100/300 AREA UNIT MANAGERS MEETING
APPROVAL OF MEETING MINUTES

November 4, 2010

100 & 300 AREA UNIT MANAGER MEETING MINUTES**Groundwater and Source Operable Units; Facility Deactivation, Decontamination, Decommission, and Demolition (D4); Interim Safe Storage (ISS); and Mission Completion****November 4, 2010****ADMINISTRATIVE**

DCN- 0100H-DD-C0243-01-01

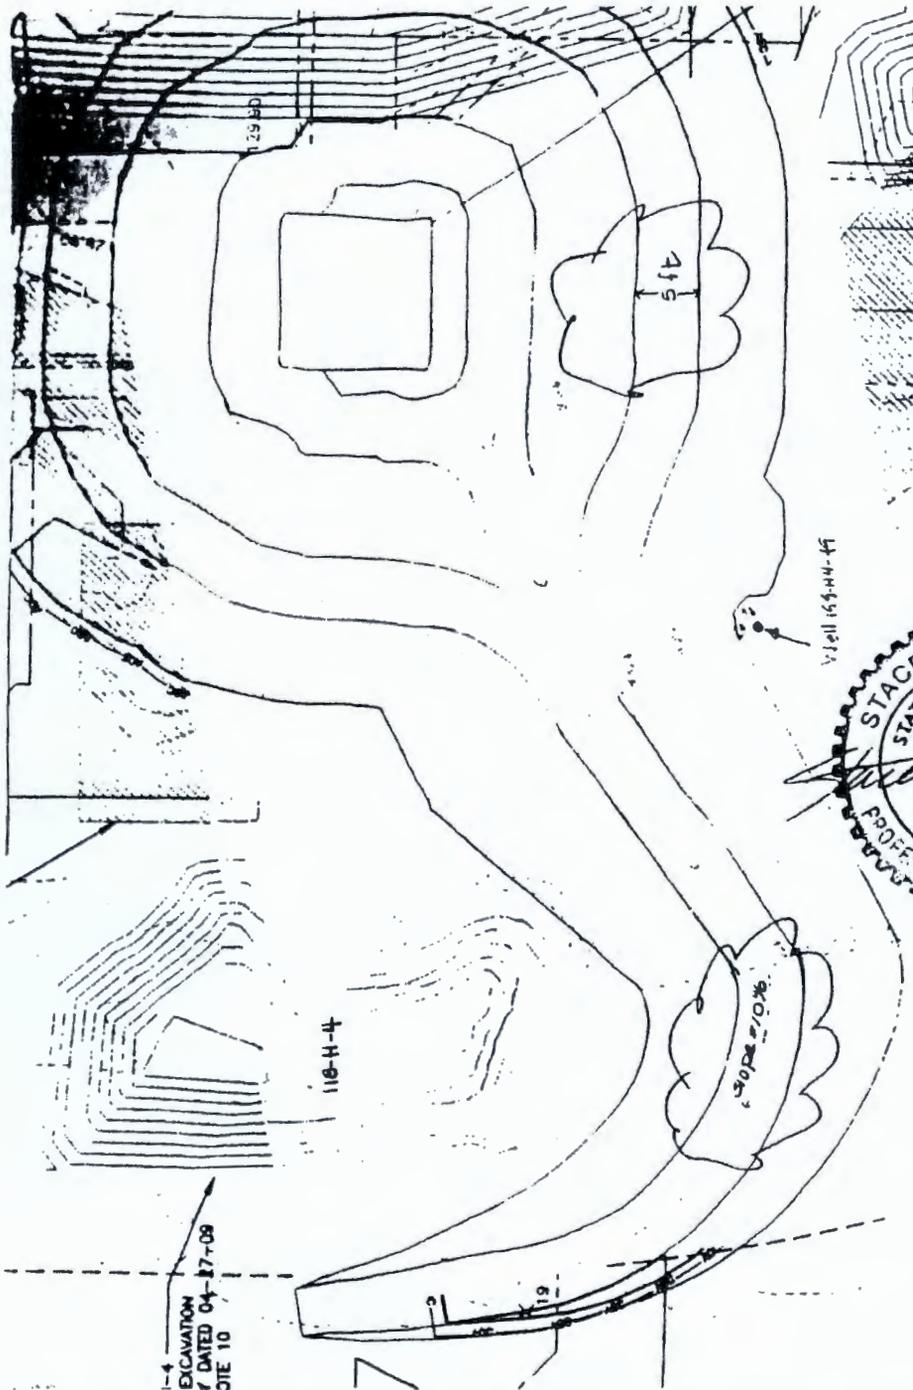
Hi Mandy, we need to modify the drawing for the 132-H-3 to increase the grade for the entry ramp from 6% to 10% to allow rock trucks to get deeper into the excavation to load out material, see attached drawing. It looks like a small portion of the layback to the south of 118-H-4 may be impacted. We will make every attempt to avoid taking any material associated with the upper portion of the south layback of 118-H-4 if I can convince operations that a 1.5 to 1 slope isn't necessary since personnel shouldn't be accessing any portion of the site near that area. I believe the CVP for 118-H-4 has already been reviewed by Ecology and you and Megan's group are finalizing

<<100-H Proposed Ramps and Stack Remediation - 1_01.png>> <<100-H Proposed Staging Area Expansion.PNG>>

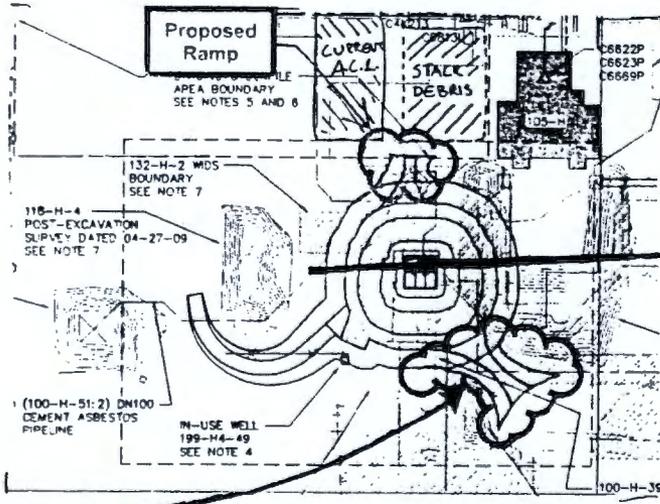
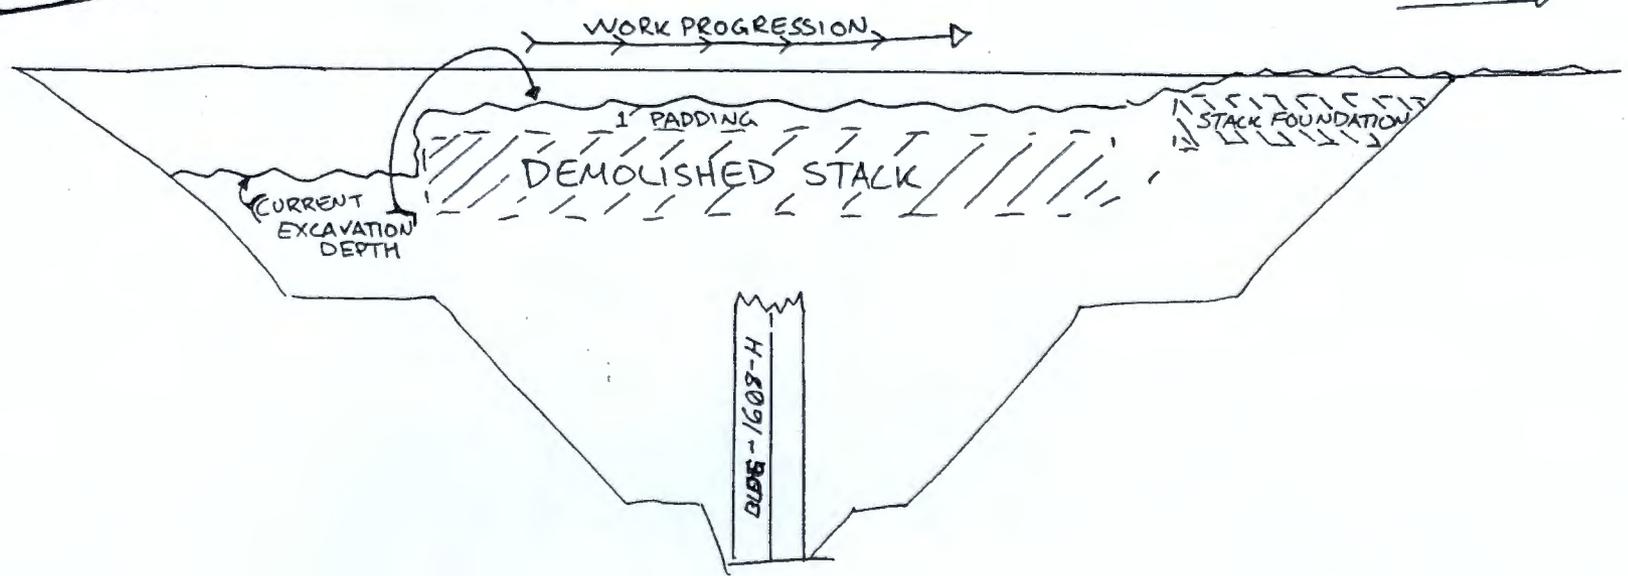
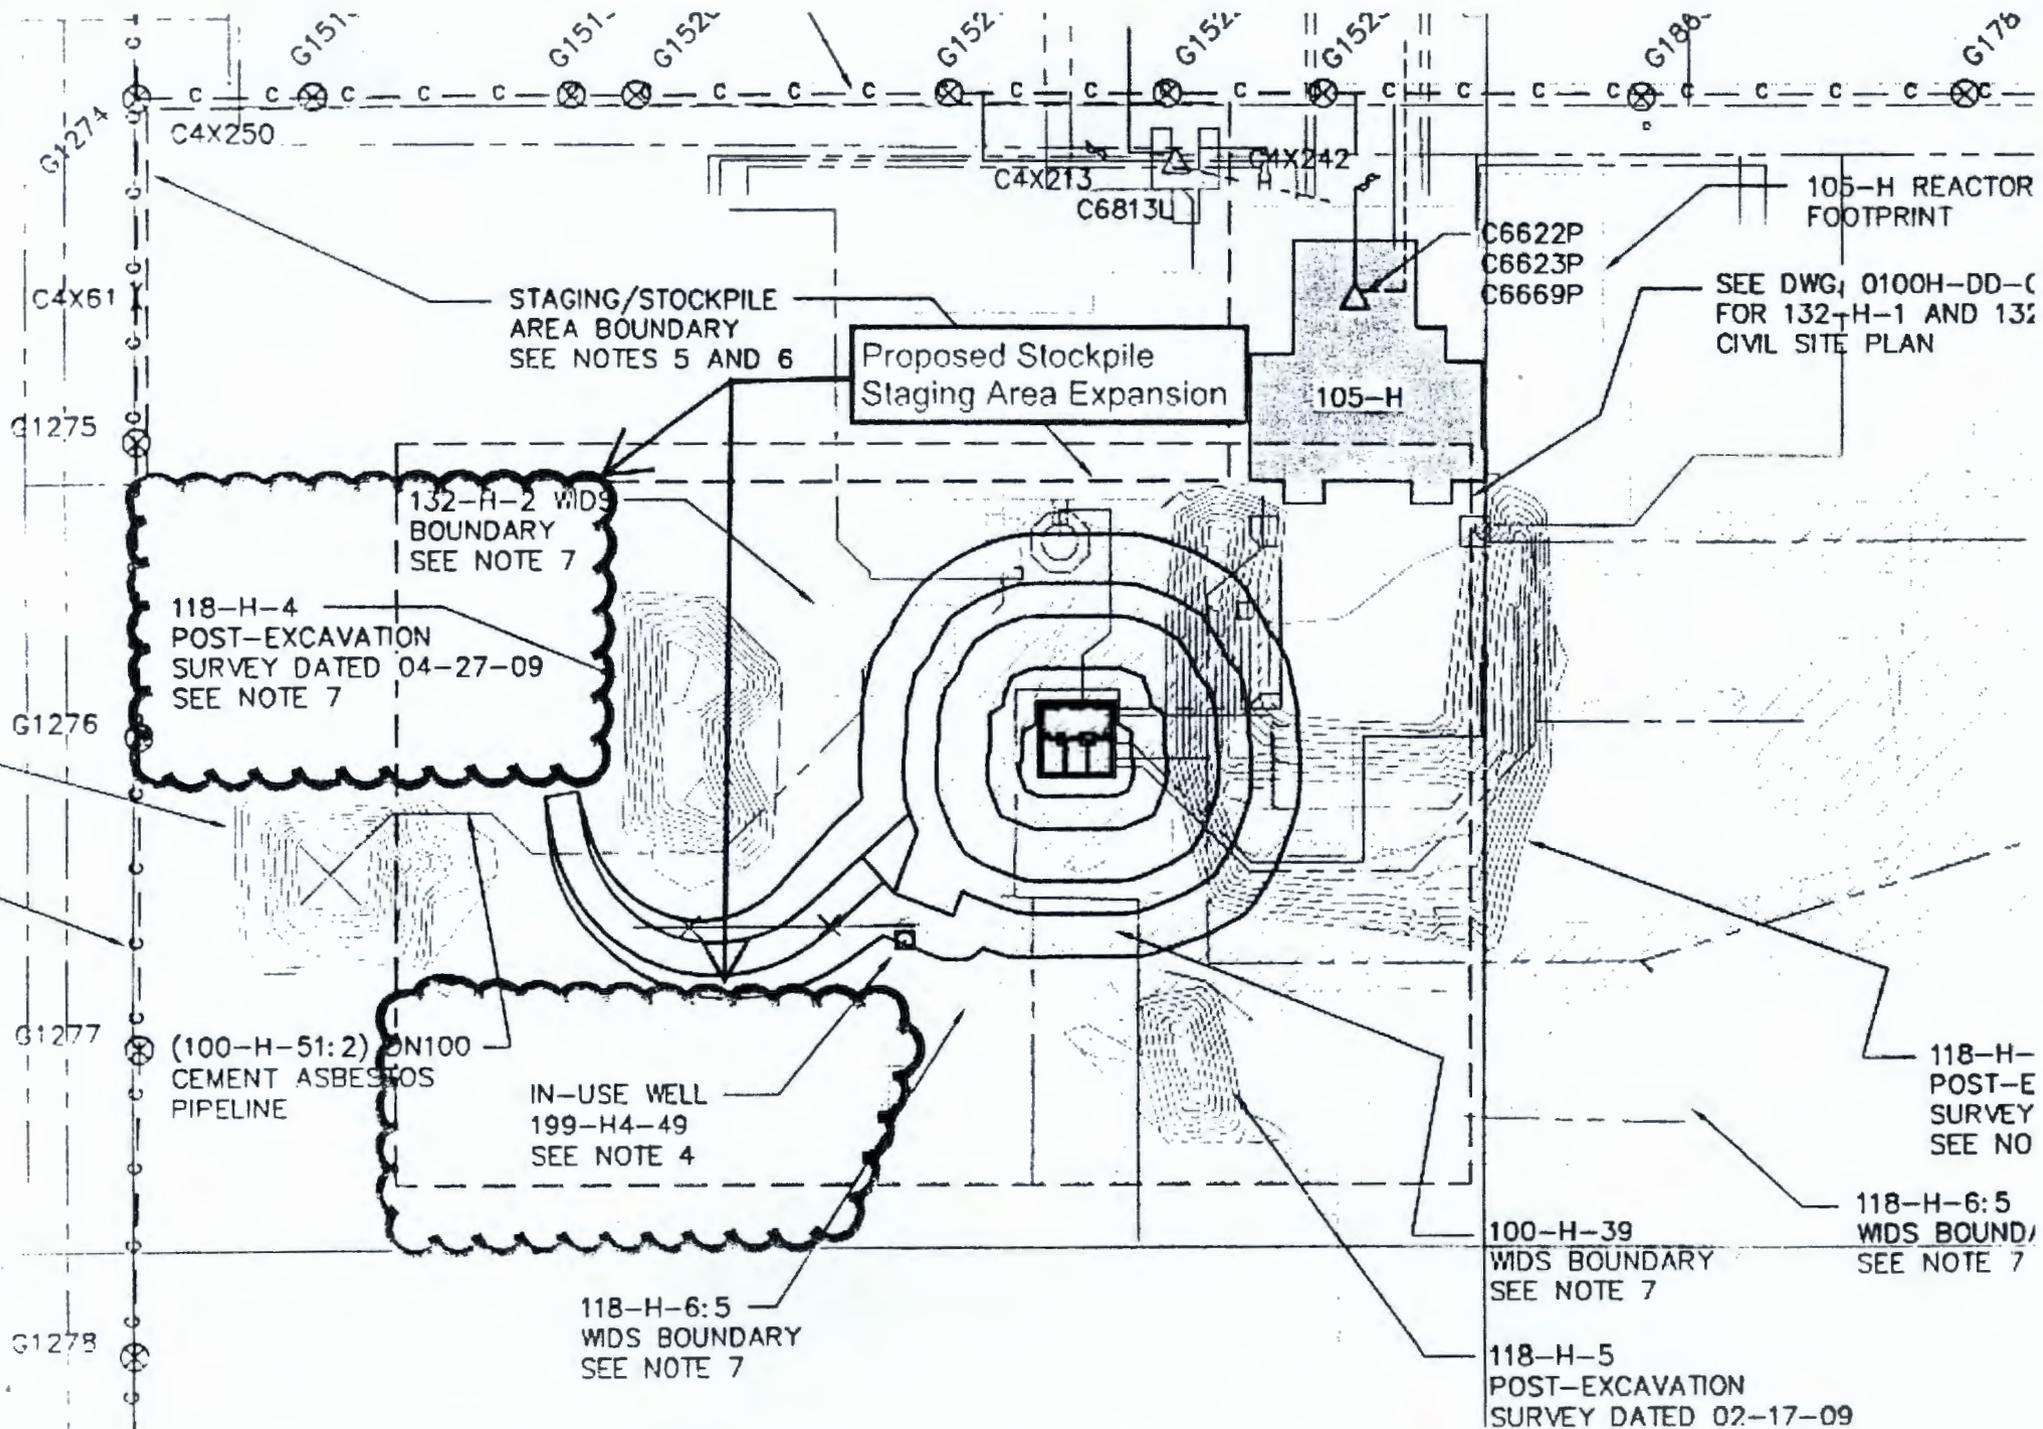
I am taking over the RE position at 100-H. I have talked with John Marthini, the subcontractor's site supervisor, and he has concerns that the ACL volume in the 132-H-3 will be greater than expected. He would like to be able to extend the stockpile staging areas if necessary. The north stockpile is an extension of the stockpile approved last month. Attached is a sketch of the areas. To let you know, we inadvertently staged waste (BCL) in the requested north stockpile shown on the attached sketch. Once the error was identified, we immediately requested the subcontractor to cease stockpiling in this area until we received concurrence from DOE and Ecology.

In addition to the stockpile areas, the subcontractor also needs to build two more ramps. One on the southeast side to facilitate the remediation of the 132-H-3 site. The other is on the north to facilitate the remediation of the 132-H-1, 116-H Reactor Exhaust Stack Burial Site.

If DOE is in agreement; based on the information provided, Ecology is approving the request for additional staging pile areas for the 132-H-3 waste site, as identified on the drawing provided October 7th, 2010.

Please ensure that these staging piles are operated in accordance with the Section 4.5.2 in the RDR/RAWP for the 100 Area, DOE/RL-96-17, Rev 6. Additionally, please ensure that all contaminants of concern (COCs) for 132-H-3 are carried forward into the verification sampling plan for these staging pile locations.

It is unclear from your e-mail if you intend to use these staging pile areas for soil from 132-H-1 waste site also. If these staging pile areas are also used to stage soil for 132-H-1, the COCs for 132-H-1 will also need to be carried forward into the verification sampling plan for these staging pile locations.

DRAWING NO.	REV. NO.
01000-DD-C0493	3

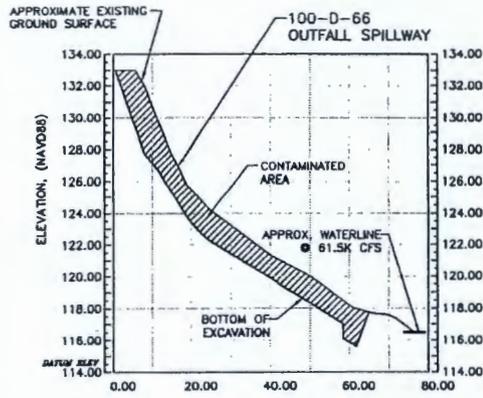
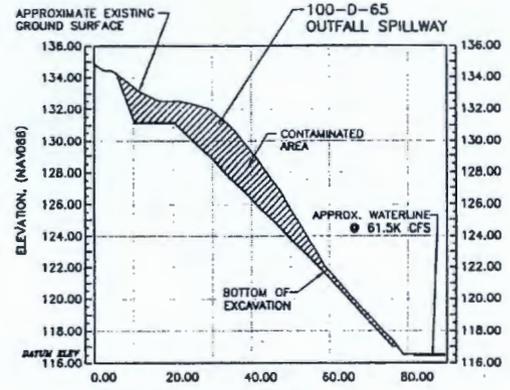
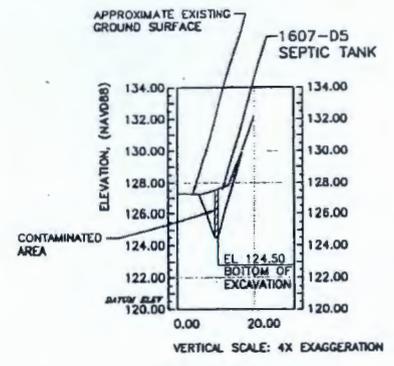
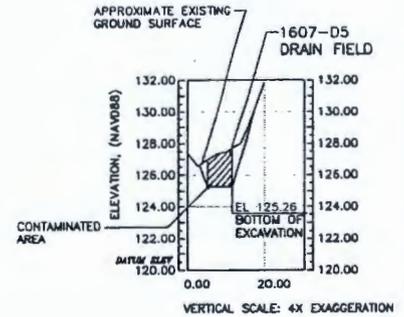
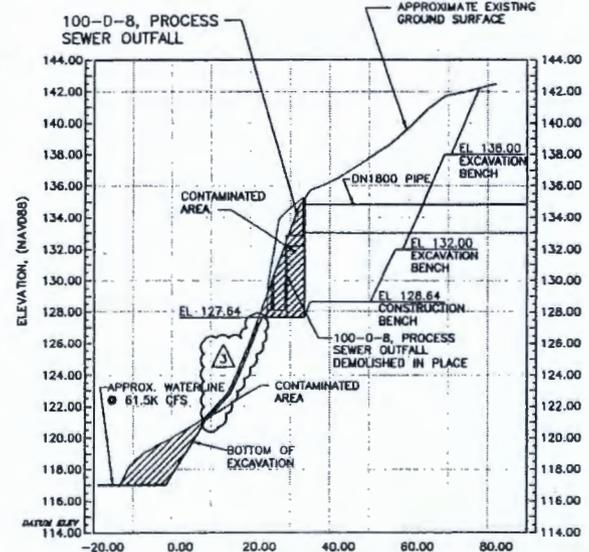
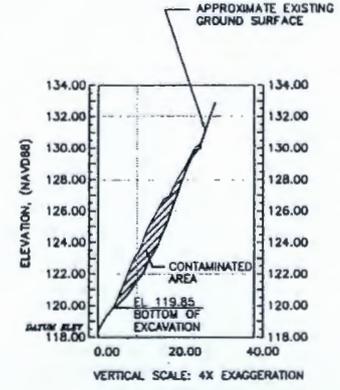
3. Cross section "D" on drawing 0100D-DD-C0493 shows contaminated areas at the top and bottom of the outfall. The area in between is not shown as contaminated. The basis for this is not clear. The area in-between should be noted as contaminated and removed to ERDF.

3. Drawing 0100D-DD-C0493 needs to be updated to include the revised D cross section that was provided in response to Ecology comment by WCH on 8/26/10. Please provide this.

100 D/DR AREA
 FY08 REMAINING SITES REMEDIAL ACTION
 CIVIL PLOT PLAN - 1: 100-D-66

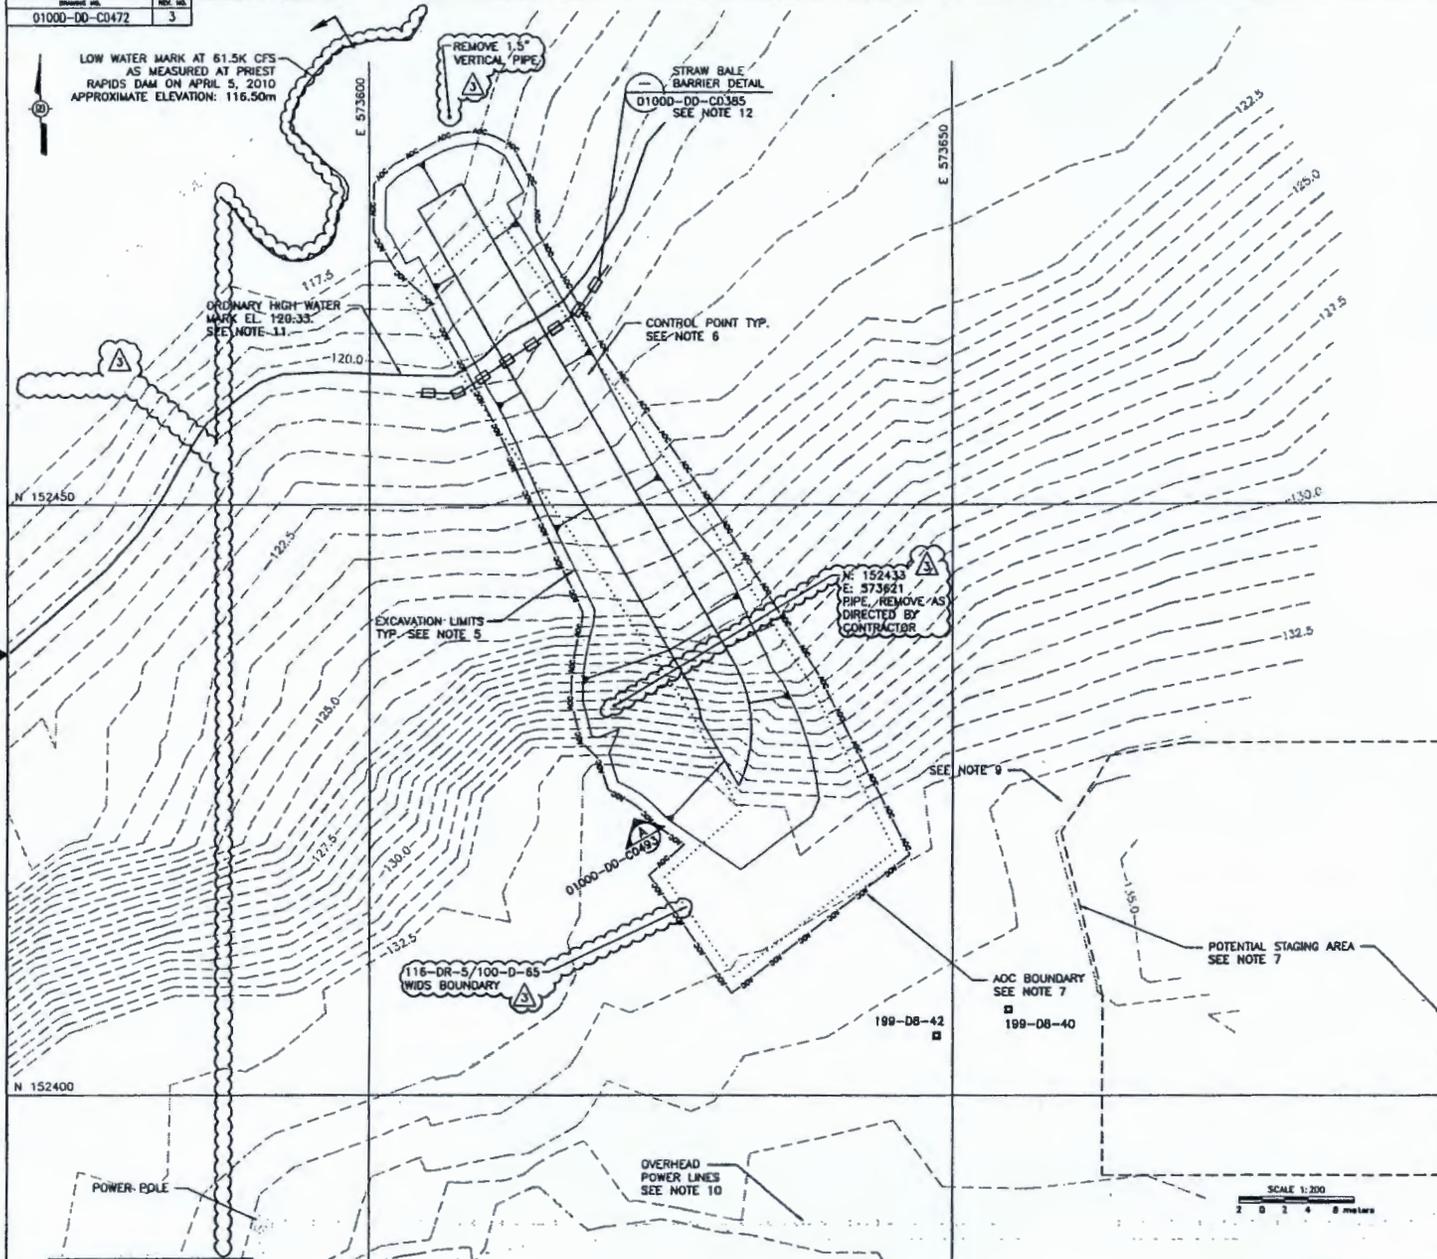
2. Drawing 0100D-DD-C0472 needs to clearly document that all of the spillway will be removed, including the area northwest of the "project limits" identified on this drawing. Add a note stating, "The entirety of the spillway, including all concrete structures, rip-rap, and grout will be removed to a maximum extent of the ordinary low water mark." Also, it is not clear what the line identifying the "project limits" identifies, please clarify.

3. Drawing 0100D-DD-C0472 identifies the 116-DR-5 WIDS Boundary. Is this truly the 116-DR-5 outfall boundary or the 100-D-66 spillway boundary? Please clarify and correct.

For the spillway sites, we need some revisions to drawings:
100-D-66 Drawing updates -

- Add note per comment #1
- Remove project limit and add note per comment #2
- Revise drawing label per comment #3
- Add note per comment #6

100 D/OR AREA
FY08 REMAINING SITES REMEDIAL ACTION
CIVIL PLOT PLAN - 2: 100-D-65

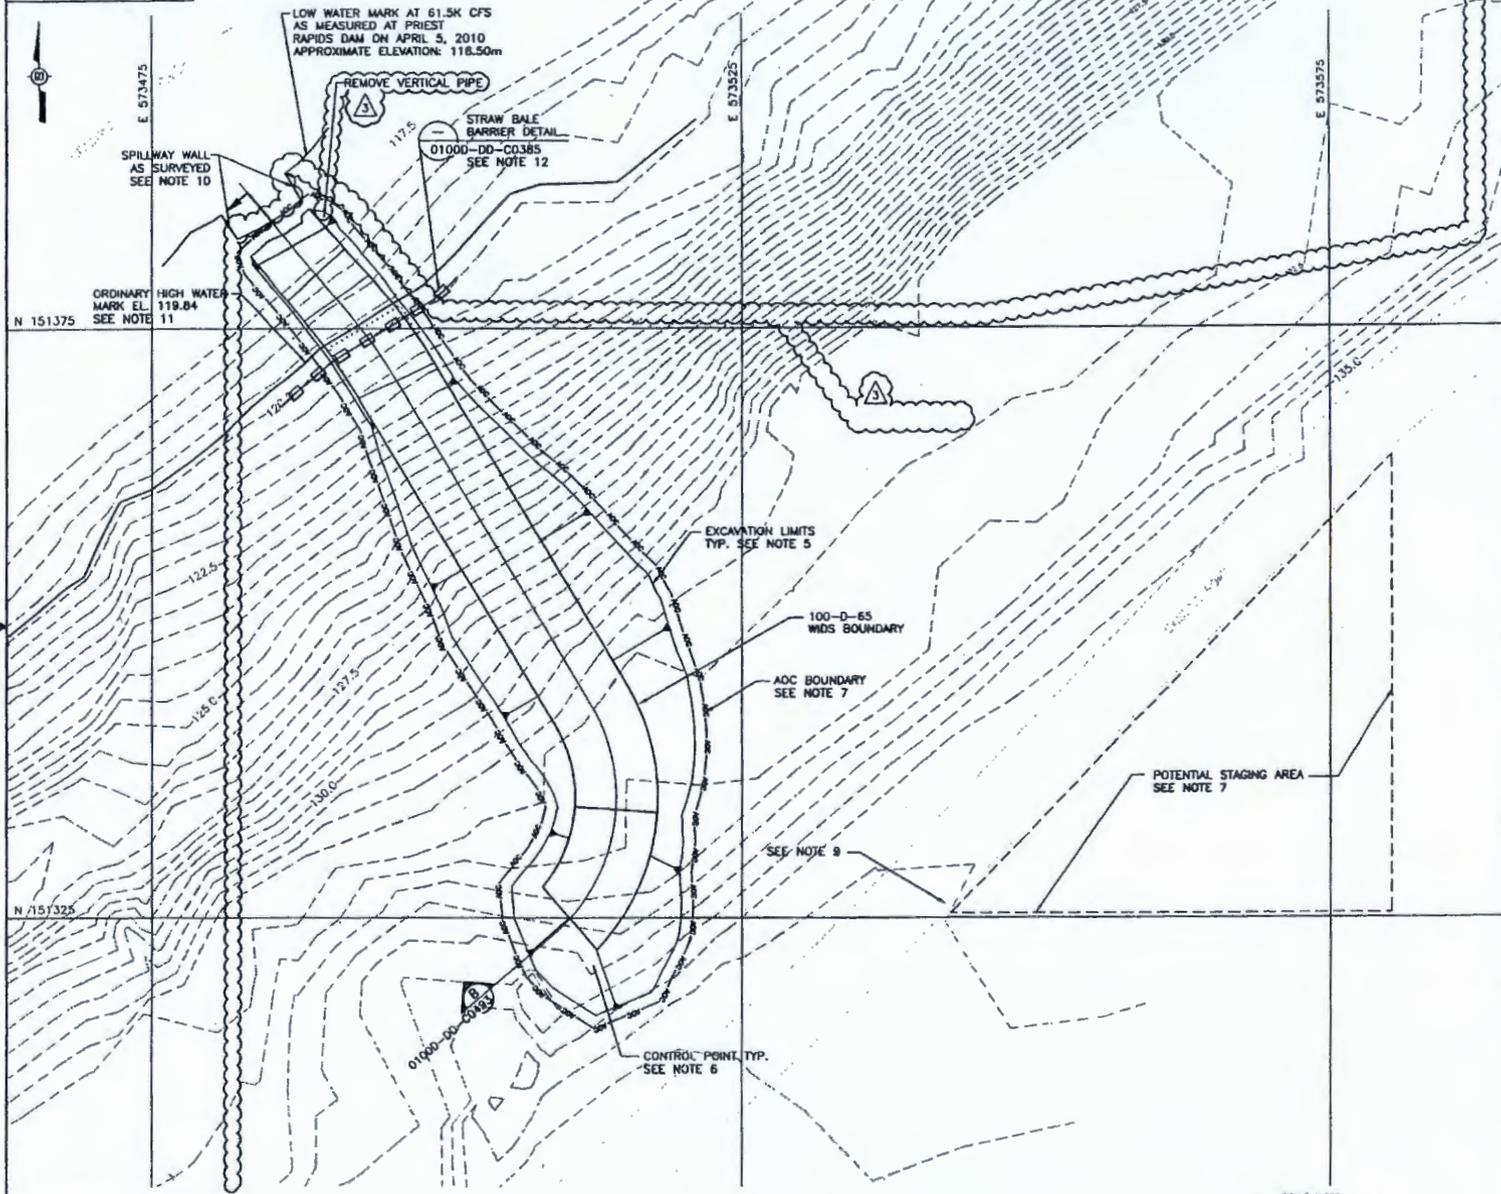
2. Drawing 0100D-DD-C0473 refers to a vertical pipe. Please confirm that this pipe will be removed.
